S E R V I C E N O T E

HP MODEL 8654A SIGNAL GENERATOR

Serial Prefix 1530A and Below

MICROPHONICS REDUCTION KIT

Figure 1. Top View with Kit Installed

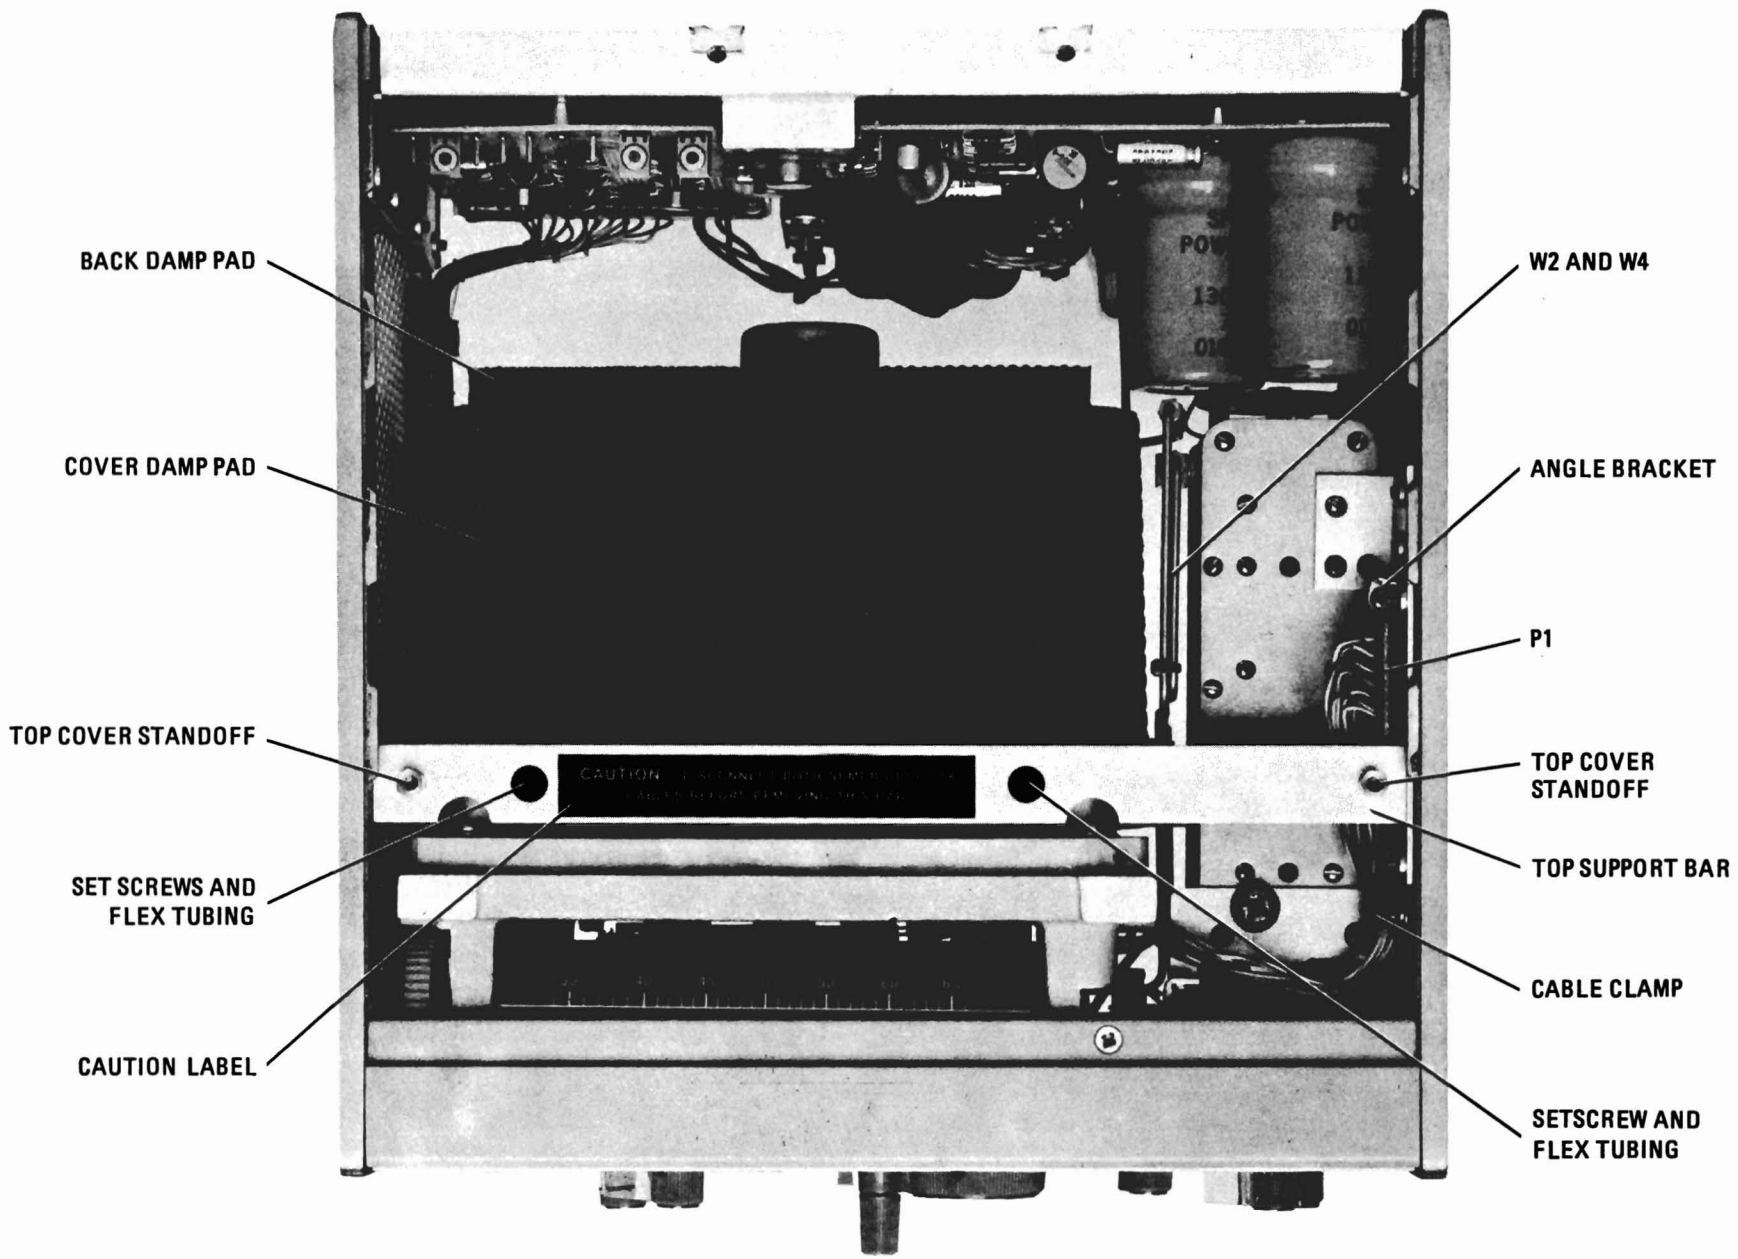
1. Peel backing from foam damp pads (HP 1530-1766 and 1530-1767) and apply to back and sides of new RF assembly cover.
2. Peel backing from caution label (HP 7120-4628) and stick label to top support bar (HP 08654-20069) as in Figure 1.
3. Apply a drop of Loctite to threads of two standoffs (HP 08654-20080) and screw into top support bar as in Figure 1. Note that they go on the side opposite the two counter-bored holes. Tighten standoffs slightly with a wrench but do not overtighten. Let dry overnight.
4. Degrease four setscrews (HP 3030-0564). Apply a drop of Loctite to bottom threads. Screw into RF assembly cover until 5/8 inch (15 mm) or slightly less protrudes on outside. Let dry overnight.

1. Remove instrument top, bottom, and side covers.
2. Remove two L-brackets from top of sideframes.
3. Remove TUNE and RANGE knobs.
4. Disconnect two semi-rigid coax cables (W4 and W2) that lead to RF assembly. See Figure 1.
5. Unplug interconnect plug (P1) on sideframe.
6. Remove cable clamp that secures wiring harness to sideframe (near P1). Clip cable ties around right support.
7. Remove four supports that secure RF assembly to sideframes.
8. Carefully remove RF assembly from instrument.
9. Remove RF assembly cover.

3. Set RF assembly into instrument.
4. Install top support bar onto top of sideframes with four 6-32 x 0.375" flat-head screws. See Figure 1. All four damp pads and setscrews (with tubing) must fit into the proper support bar holes. If top support bar is difficult to fit into place, loosen upper screws in one of sideframes and try again.

Figure 2. Bottom View with Kit Installed

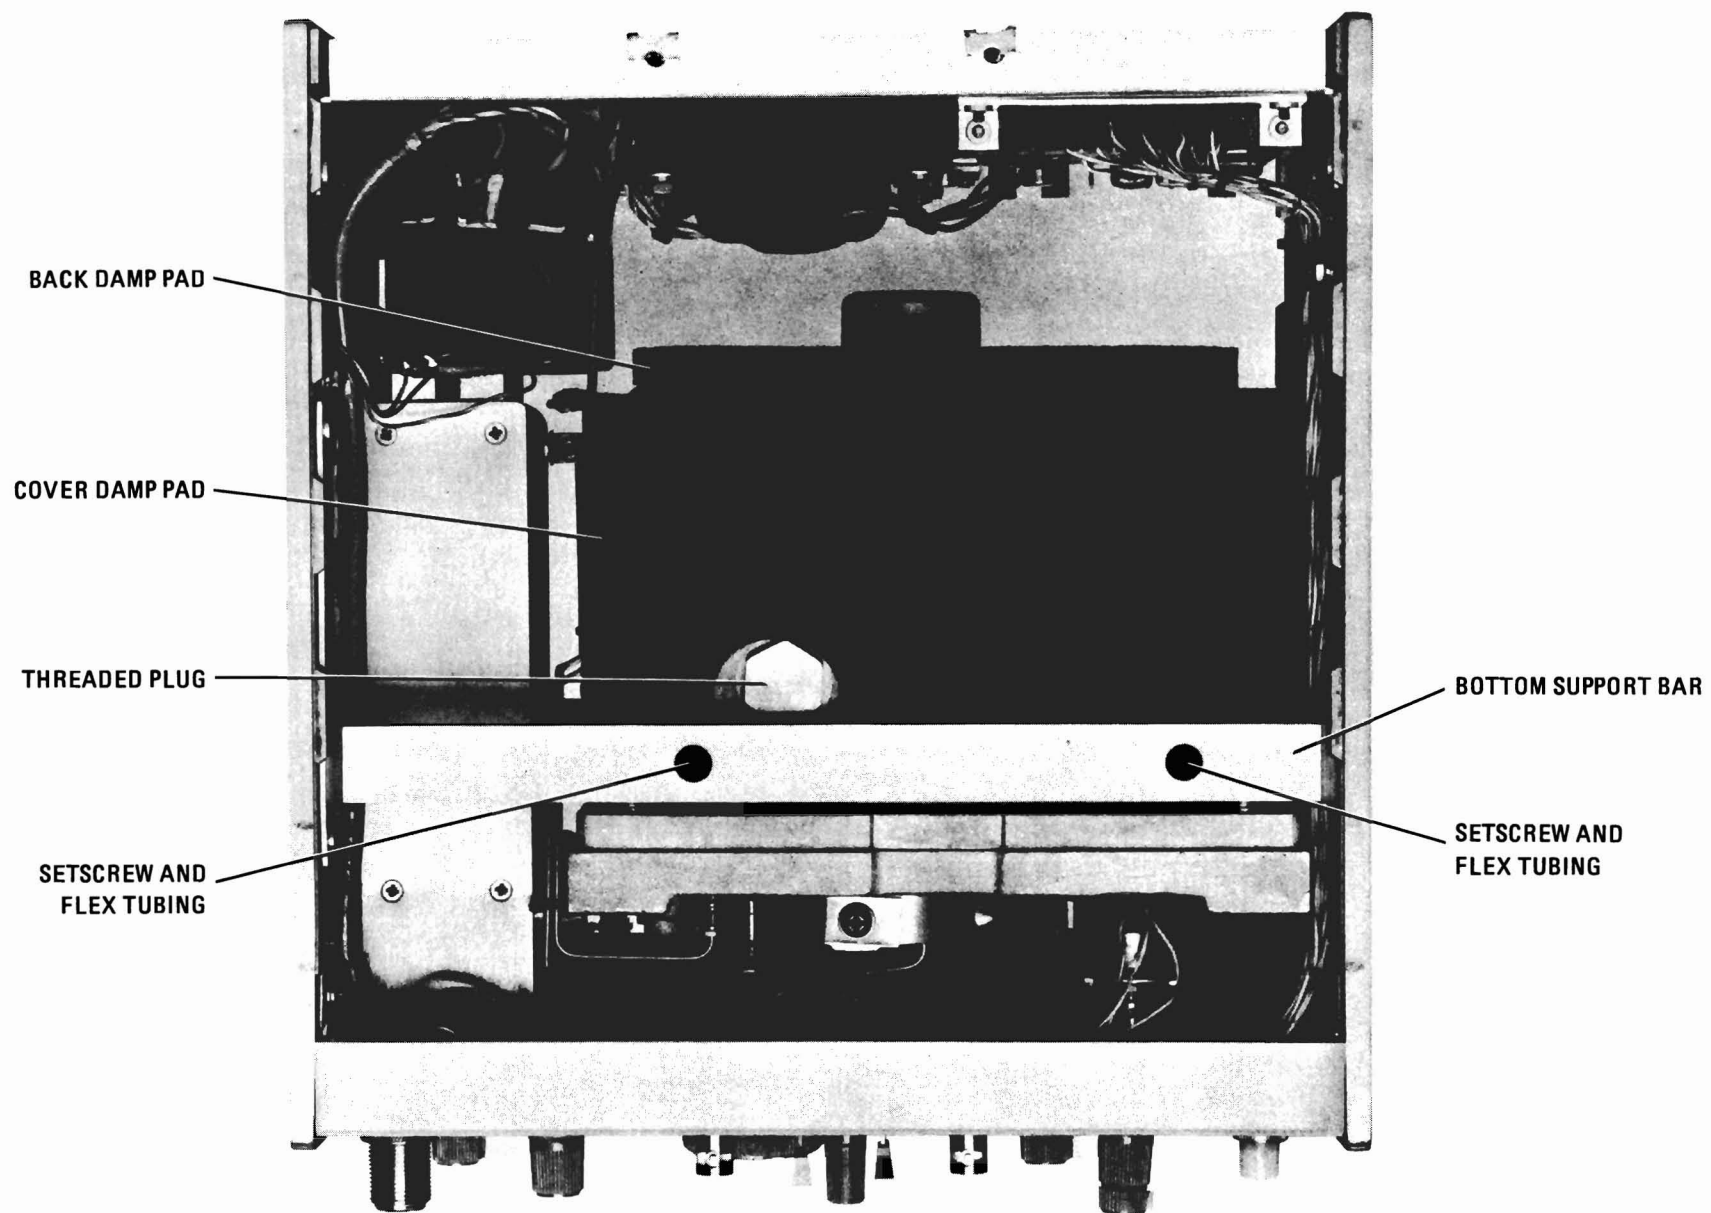
1. Install bottom support bar (HP 08654-20071) onto bottom of sideframes with four 6-32 x 0.375" flathead screws (HP 2360-0118). See Figure 2.
2. Before installing RF assembly:

Figure 3. Right Side View with Kit Installed

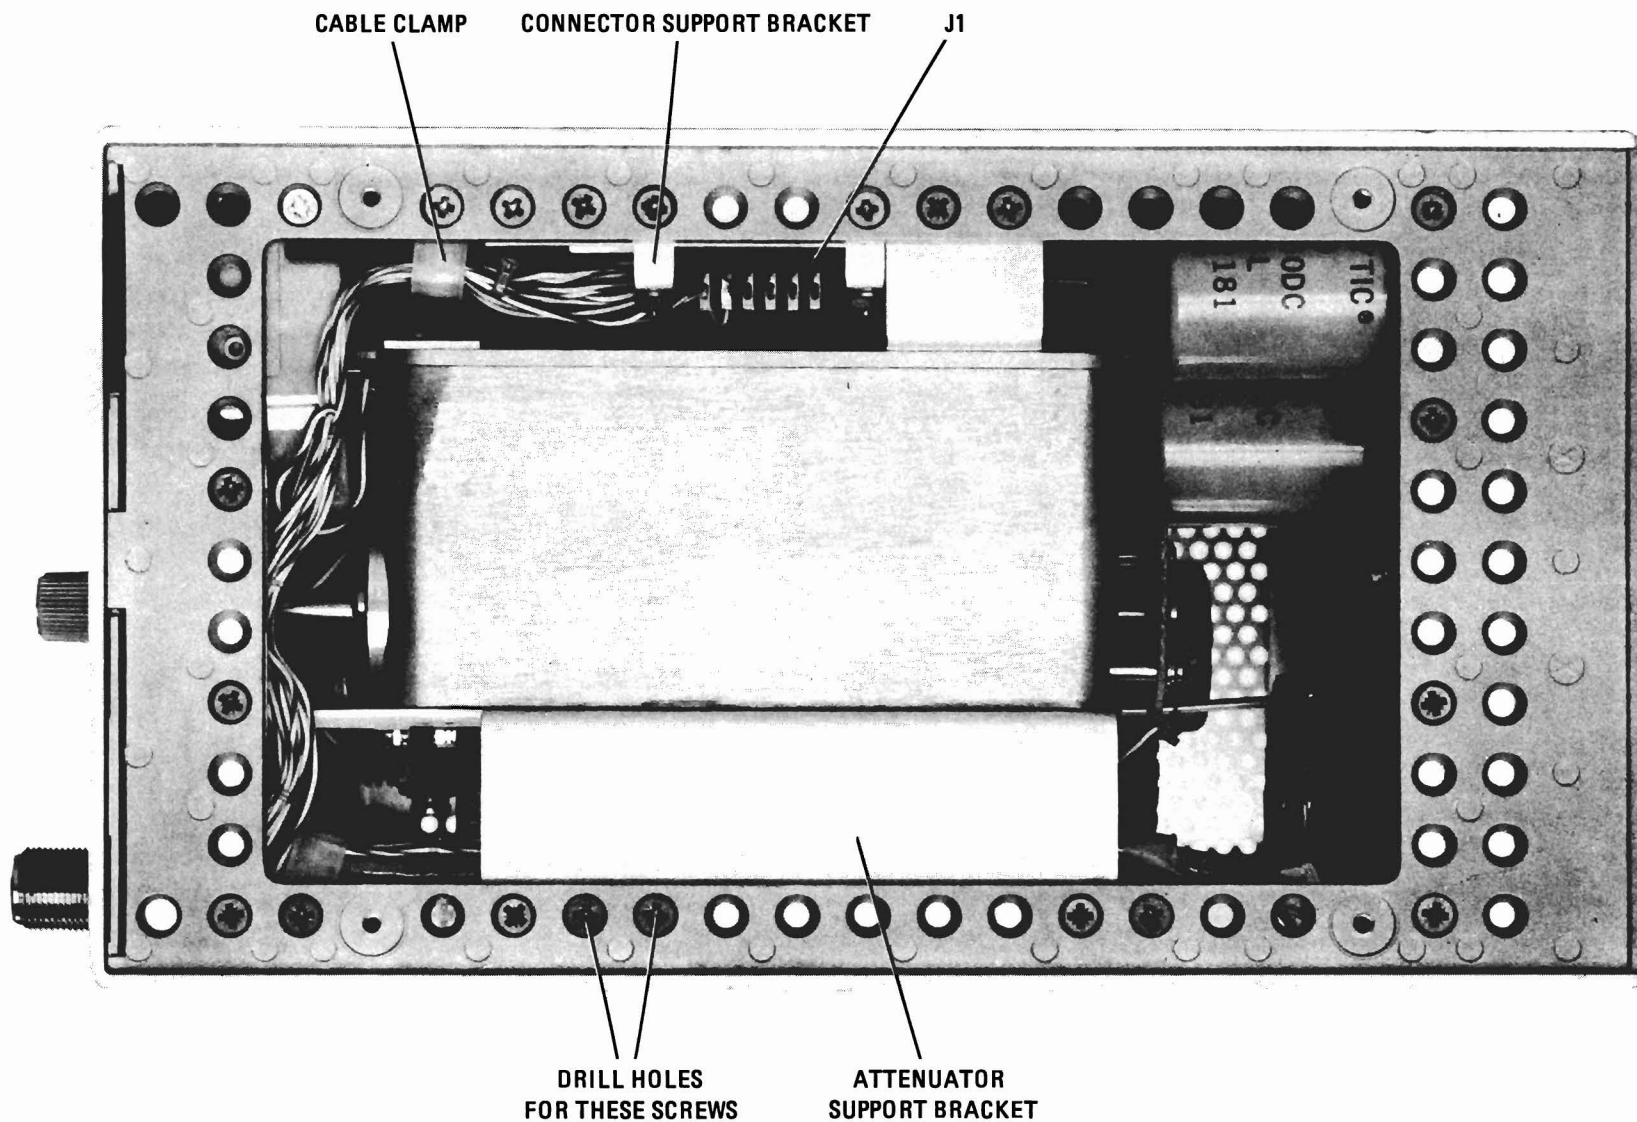
6. Install bracket onto sideframe with two 6-32 flathead screws which formerly held on the two L-brackets.
7. Drill two 5/32-inch (0.156 inch or 4 mm) holes into attenuator support bracket as shown in Figure 3. Use a center punch to locate the two holes before drilling. The support bracket need not be removed for this operation.
8. Install handle from old top cover onto new top cover.
